NEW SANCTUARY FOR  
ST. ELIZABETH CPCA  
104 PERRY ST.  
MADISON, ALABAMA 35758

- 3/16/18: ADDED A2.1 AND A2.2 DUE TO ADDING CONNECTOR ADDITIVE ALTERNATE  
A2.1 PLAN PART A (WITH CONNECTOR OPTION) 1/4"=1'-0"  
A2.2 PLAN PART B (WITH CONNECTOR OPTION) 1/4"=1'-0"  
A3 PLAN OF SANCTUARY ADDITION WITH ROOM, DOOR AND WINDOW MARKS  
A4 MEZZANINE FLOOR PLAN AND SCHEULES/NOTES  
A5 SOUTH AND EAST ELEVATIONS  
A6 NORTH AND WEST ELEVATIONS  
A7 ROOF PLAN  
LS1 LIFE SAFETY PLAN  
L1 LANDSCAPE PLAN

12/24/17: CONNECTOR OPTION WAS ADDED TO CONNECT EXISTING BUILDING AND SANCTUARY ADDITION.  
3/16/18: CONNECTOR OPTION WAS REVISED TO INCLUDE AN INTERIOR RAMP AND SOUTH EXTERIOR DOOR WAS DELETED.

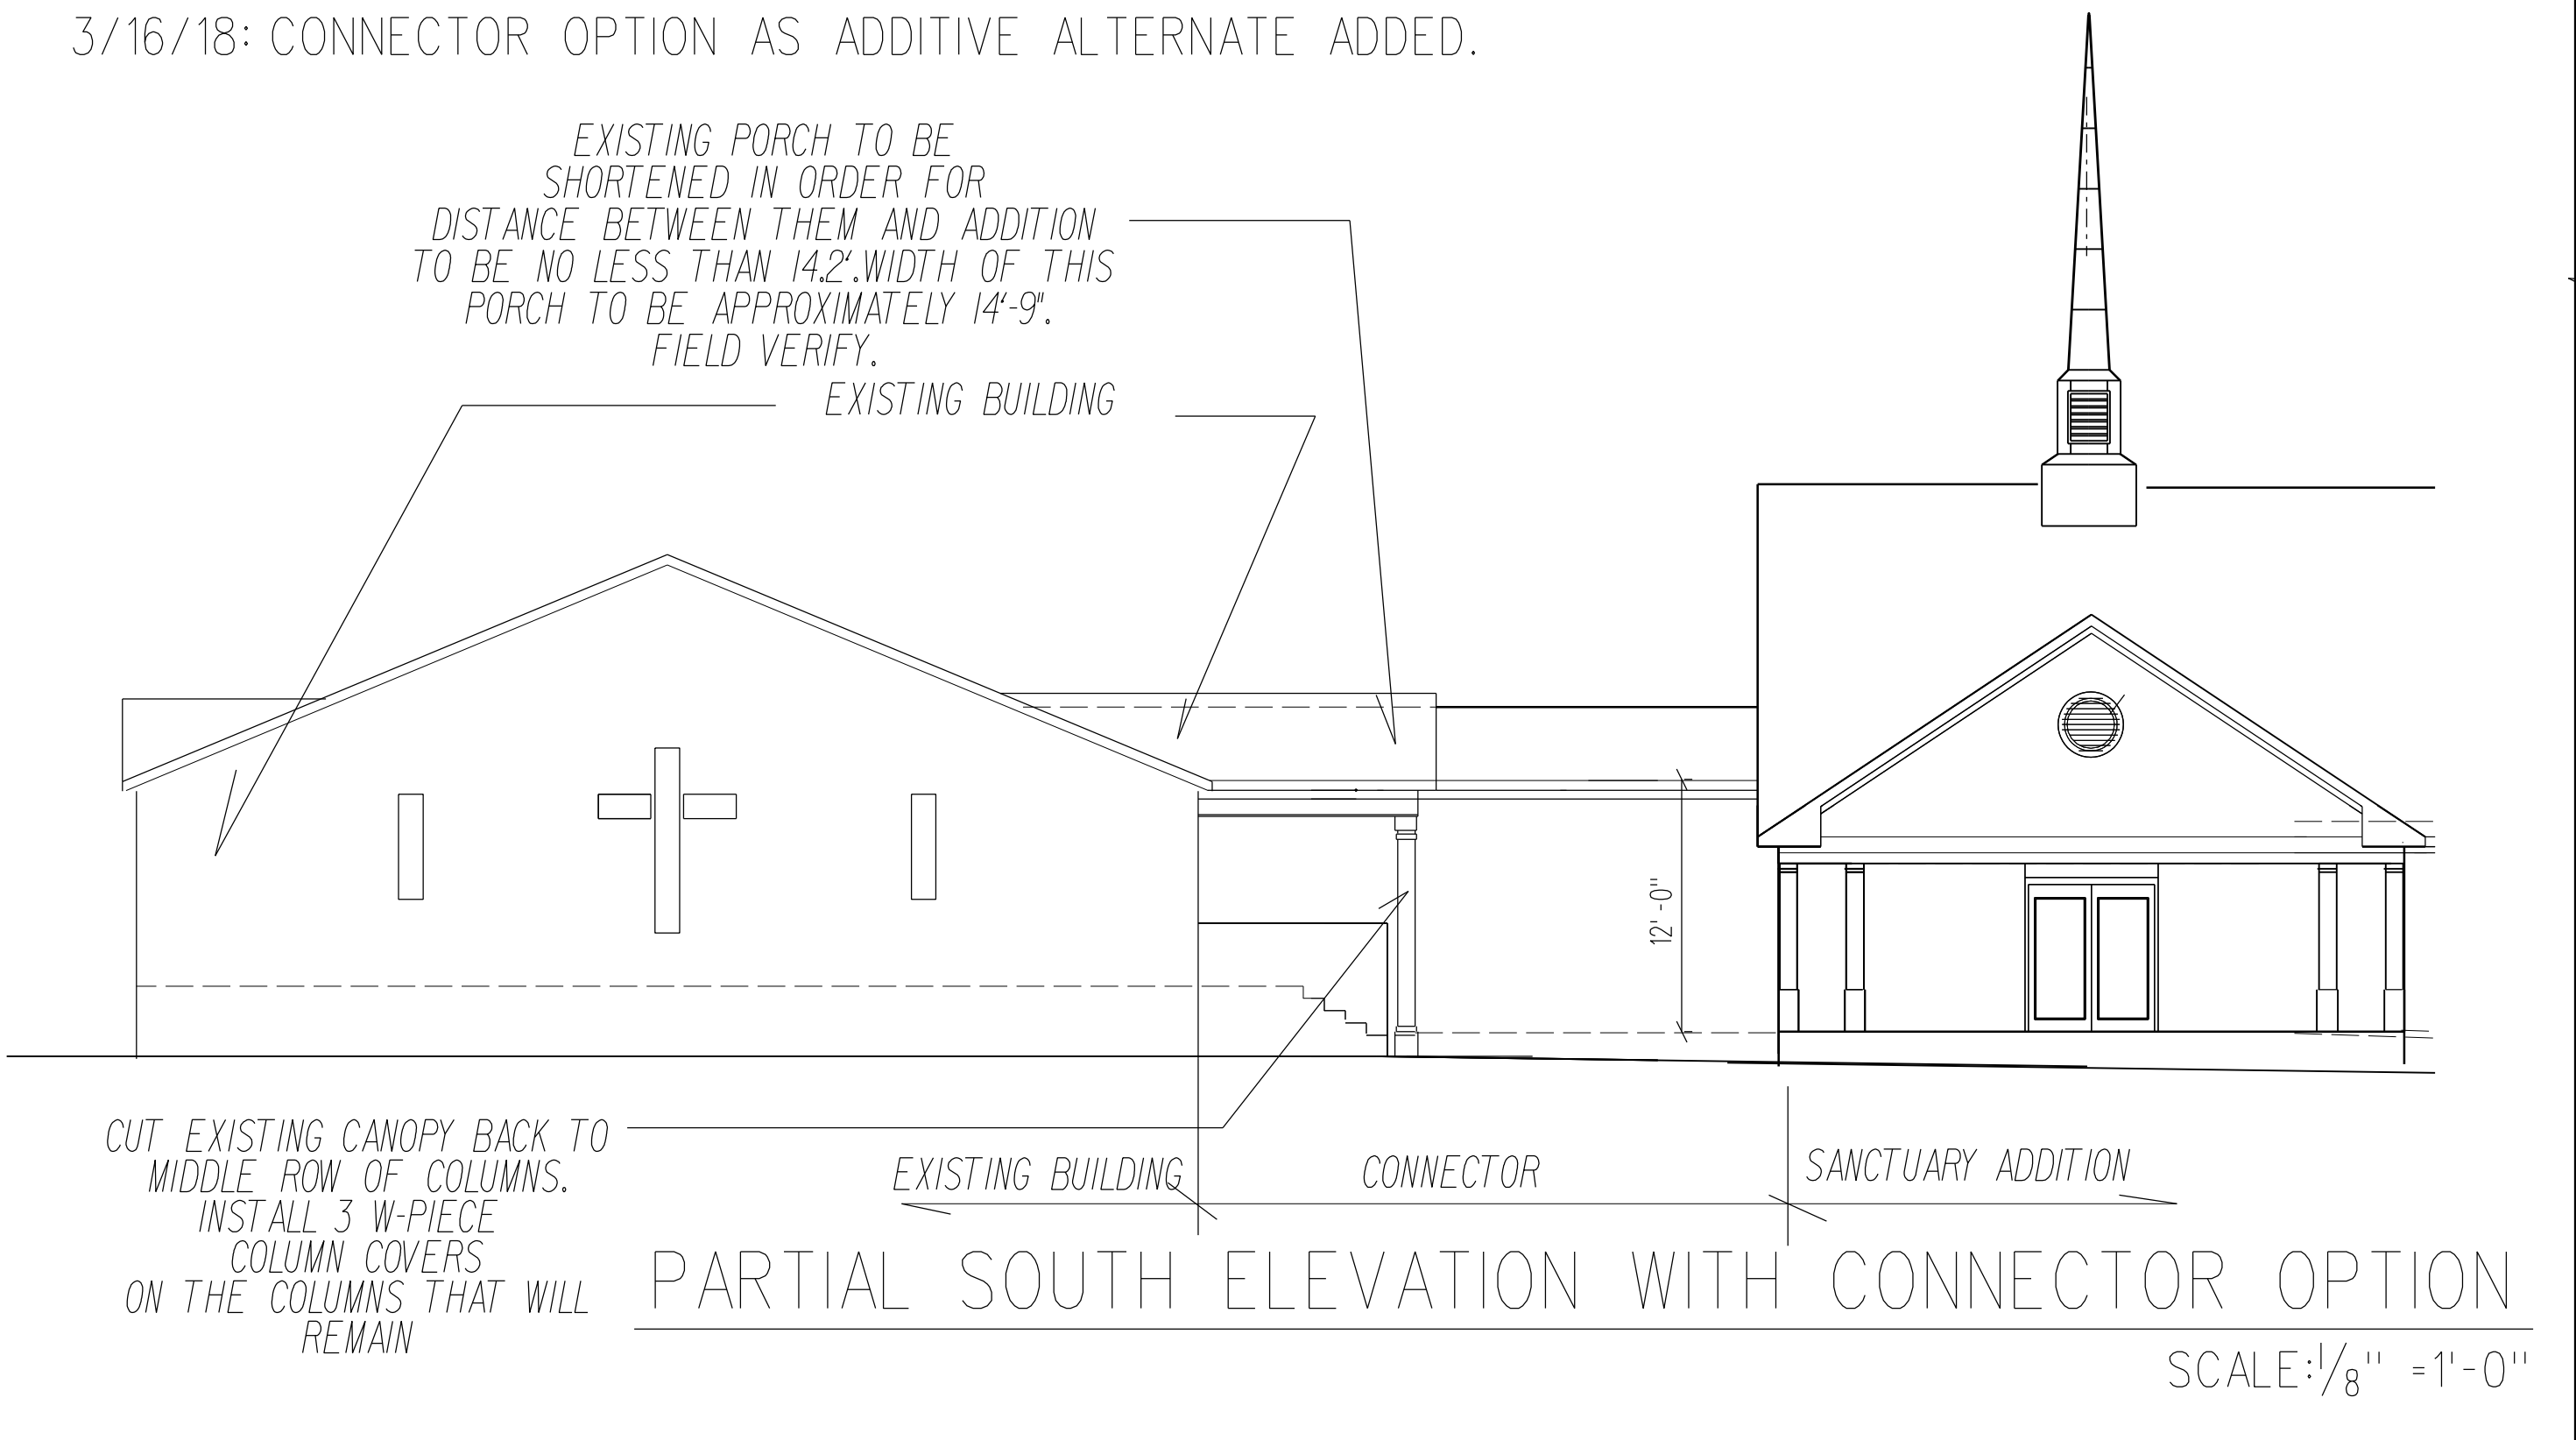
3/16/18 THIS ELEVATION WAS ADDED TO SHOW THE ADDITIVE ALTERNATE CONNECTOR AND THE SMALLER PORCH OVER THE EXISTING LANDING AND STEPS.

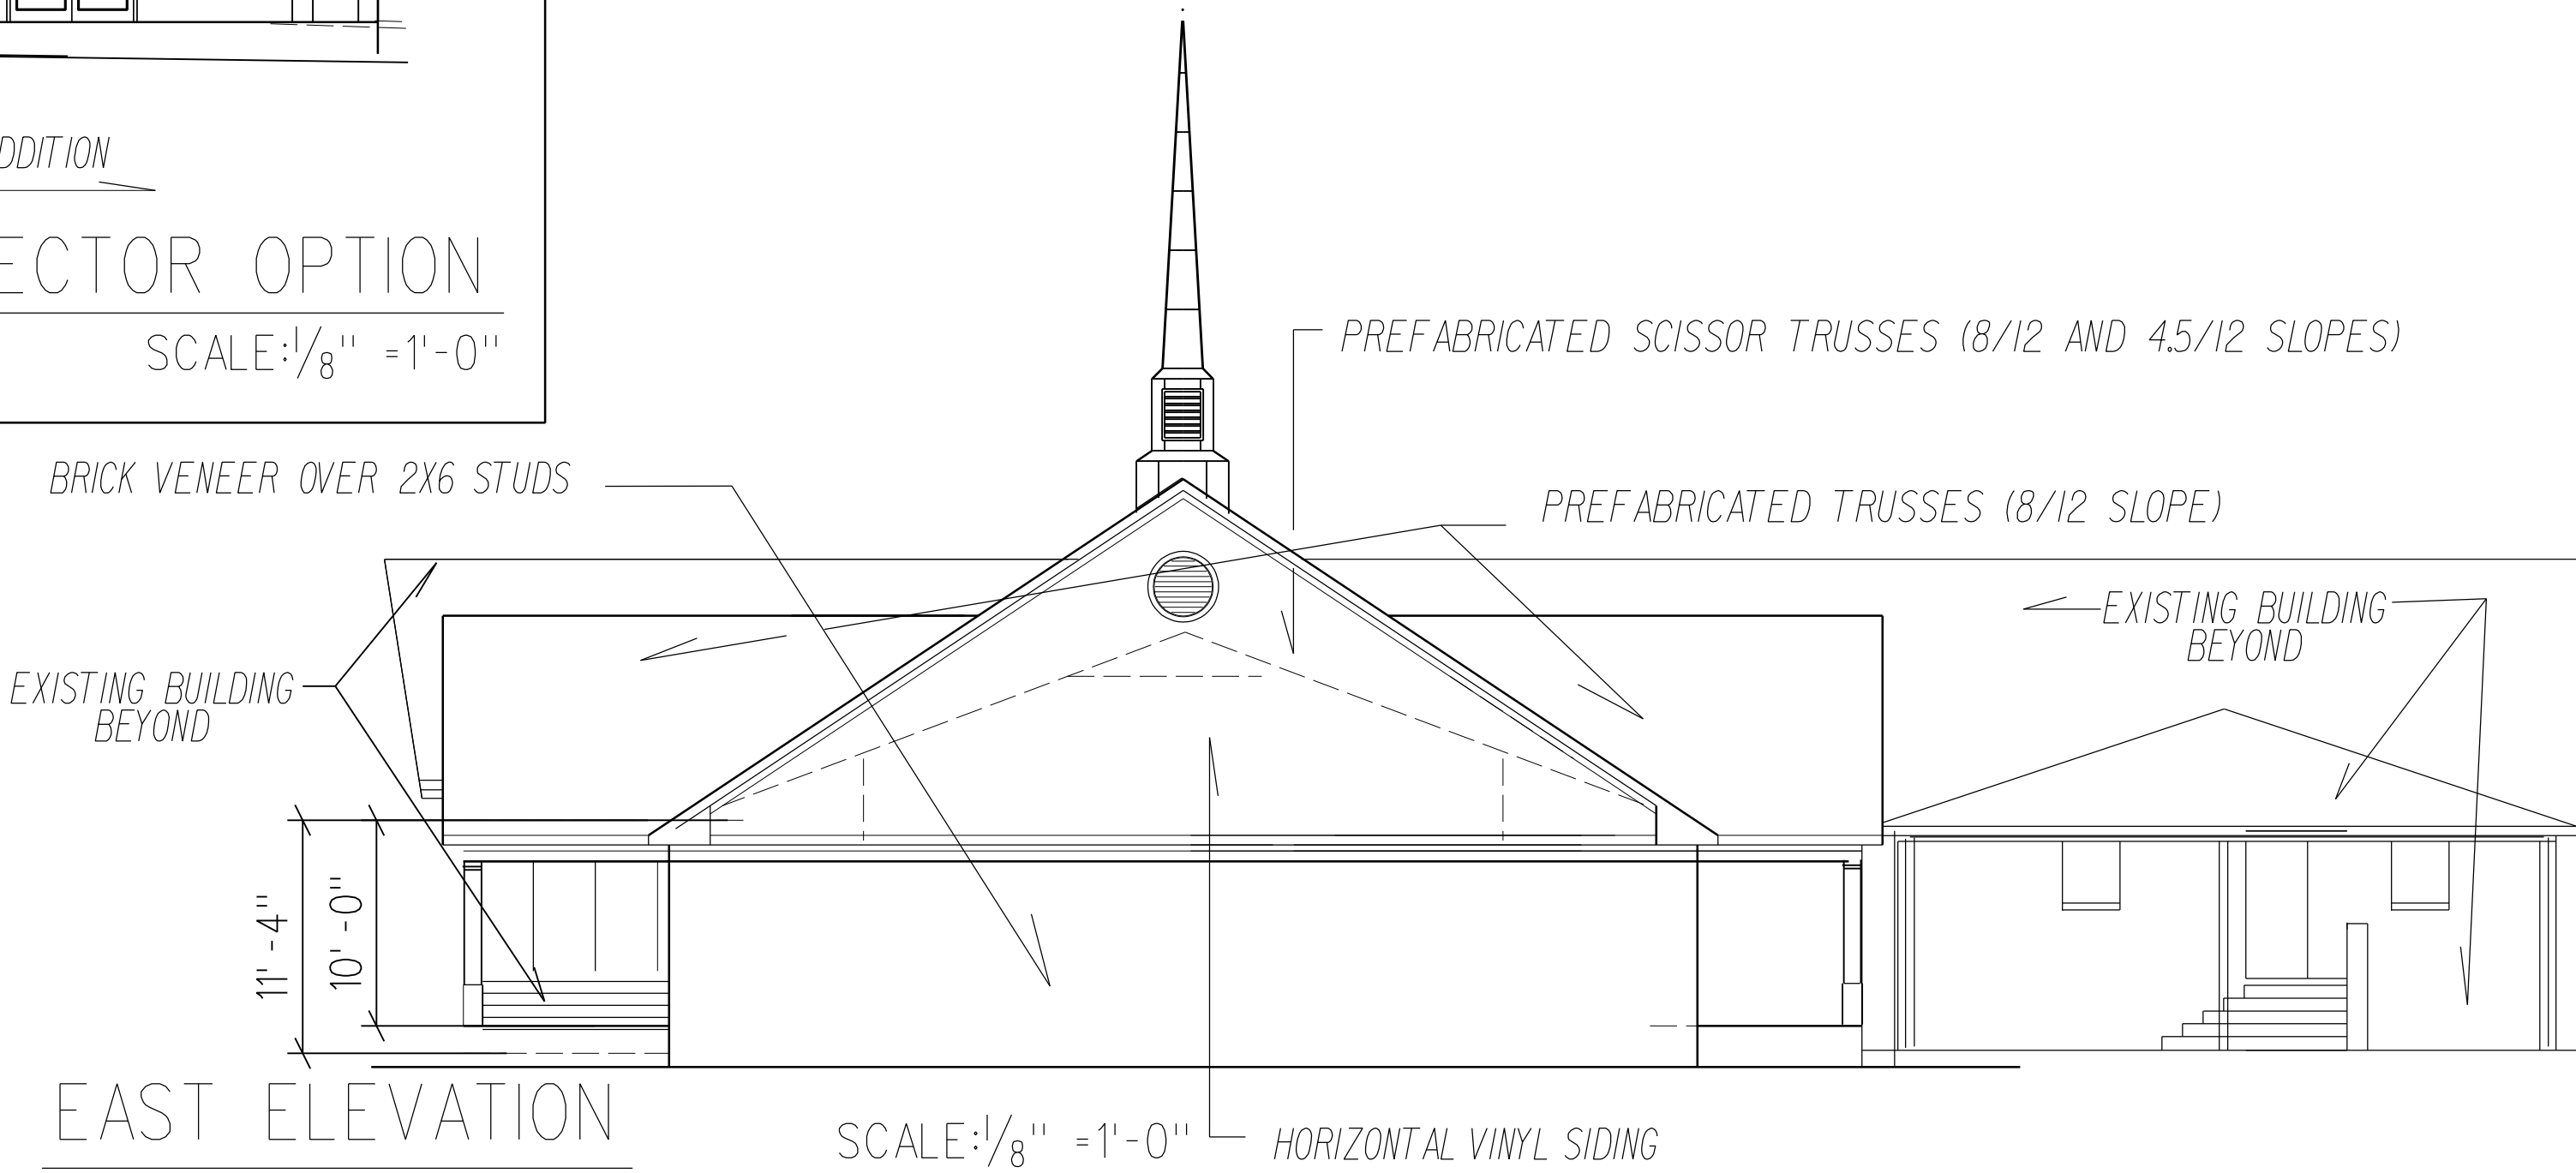
12/24/17 THIS ELEVATION WAS ADDED TO SHOW THE ADDITIVE ALTERNATE CONNECTOR AND THE SMALLER PORCH OVER THE EXISTING LANDING AND STEPS.

NEW SANCTUARY LIFE SAFETY PLAN WITH CONNECTOR OPTION

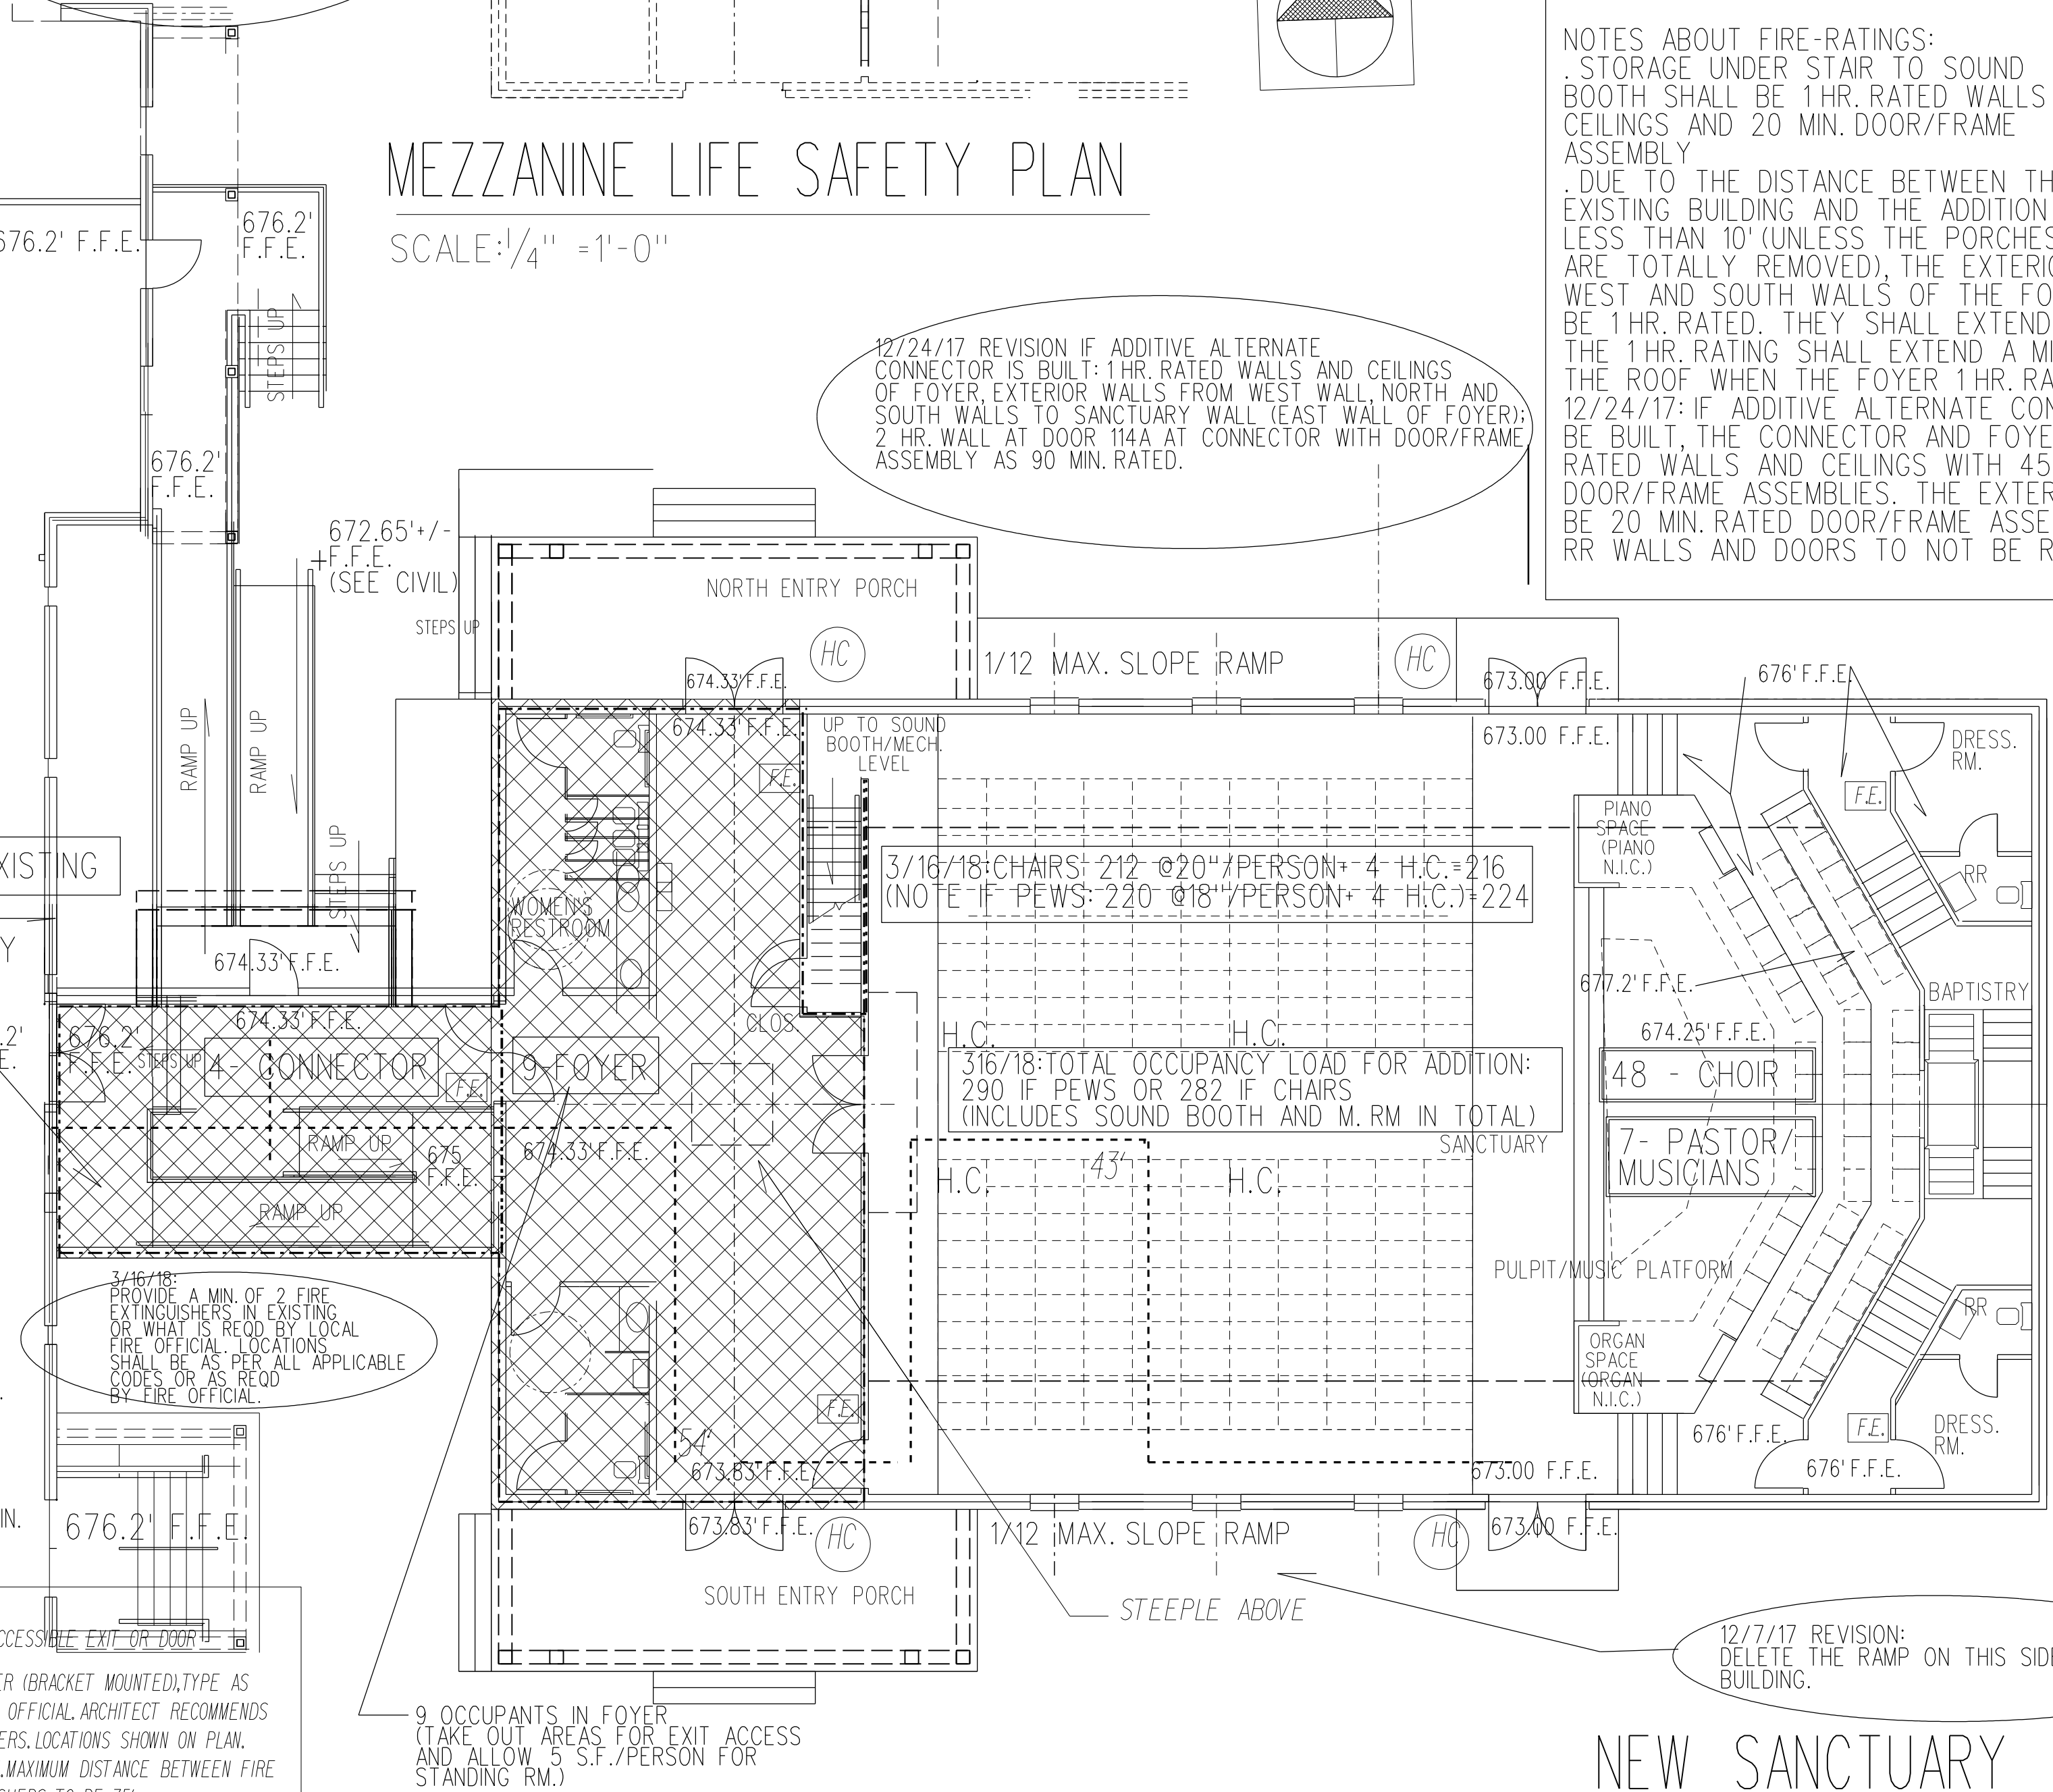
NOTES ABOUT FIRE SEPARATION BETWEEN THE EXISTING AND THE ADDITION:  
3/16/18: DUE TO FIRE SEPARATION DISTANCE BETWEEN EXISTING AND NEW BUILDINGS BEING LESS THAN 10' DUE TO THE PORCHES, THE WEST EXTERIOR WALL OF THE ADDITION, THE NORTH AND SOUTH EXTERIOR WALLS OF THE PORCHES SHALL HAVE 1HR. FIRE RATINGS. THE EXTERIOR DOORS FROM FOYER SHALL BE 20 MIN. RATED ASSEMBLY DOORS/FRAMES.  
A FIRE HYDRANT WAS ADDED NEAR SOUTHEAST CORNER OF ADDITION (SEE CIVIL) WHICH MAKES IT SAFER IN CASE OF A FIRE. THE EXISTING PORCHES WILL BE CUT BACK TO 12'6" FOR SOUTH PORCH AND 6'-9" FOR NORTH PORCH GIVING 14.2' MIN. BETWEEN THE PORCHES AND THE ADDITION. . 1HR. RATINGS AS SHOWN WILL REMAIN IN THIS CASE.  
CONNECTOR WILL HAVE 2 HR. RATED WALL WITH 90 MIN. DOOR/FRAME ASSEMBLY WITH PROPER HARDWARE THAT SEPARATES THE EXISTING AND CONNECTOR FROM THE SANCTUARY ADDITION. EACH SIDE OF THE 2 HR. WALL WITHIN 4' OF IT SHALL BE 1HR. RATED CONSTRUCTION INCLUDING ROOF DECKS. THE ENTIRE FOYER/RR AREA OF THE ADDITION SHALL HAVE 1HR. RATED WALLS AND CEILINGS (INCLUDING THE EXTERIOR WALLS, RR DOORS SHALL NO BE RATED. THE CONNECTOR SHALL HAVE 1HR. RATED WALLS (U356 EXT.; U305 INT.), 1HR CEILINGS UL P522); 2 HR. WALL UL U301 OR EQUAL.

3/16/18: OCCUPANCY LOAD OF EXISTING BUILDING AND CONNECTOR:  
223 EXISTING BUILDING (158 FORMER SANCTUARY; 2 OFFICE; 63 SS ROOMS/EDUC) + 4 CONNECTOR (WHICH IS A HALL WITH NO PEOPLE IN IT EXCEPT TO PASS TO ANOTHER ROOM)

12/7/17 REVISION: DELETE THE RAMP ON THIS SIDE OF THE BUILDING.
